Bureau of Land Management
SUNDRY NOTICES AND REPORTS ON WELLS
Albuquerque Field Office

8 Well Name and No.
Gold Medal #93S

Additional APD info

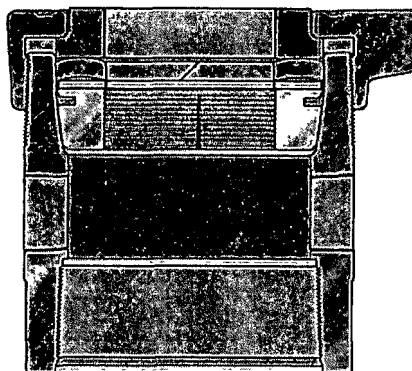
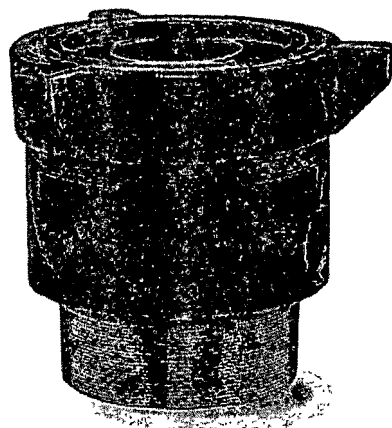
Dugan Production Corp. is asking for consent to pressure test the Blow-out Preventor Equipment (BOPE) without using a test plug because of the following reason:

Dugan uses a Gardner Denver 2000 drilling rig to drill shallow coal wells. The largest BOP that will fit under this rig is a Schafer 6" 2000 series that has an internal diameter of 7.0625". This BOP is screwed on to a Hercules LM85 casing head (1500 psi working pressure, 3000 psi test pressure, bottom thread 8-5/8" 8rd, cap thread 9-5/8" 8rd) that has an internal minimum bore of 7.920". The casing head is screwed onto 8-5/8" surface casing (24#, J-55 and 8rd thread) that has an internal diameter of 8.097".

Currently Dugan is unable to get a test plug for the casing head (7.920" ID) or surface casing (8.097" ID) that will pass through the BOP (7.0625").

Dugan will test the BOPE and surface casing together. The test will include a low pressure test to 250 psig held for five minutes and a high pressure test to 800 psig held for thirty minutes (with no more than a 10 percent pressure drop during the duration of the tests). If a 10 percent or greater pressure drop occurs, a packer will be run to isolate the surface casing and BOPE to locate the source of the leak.
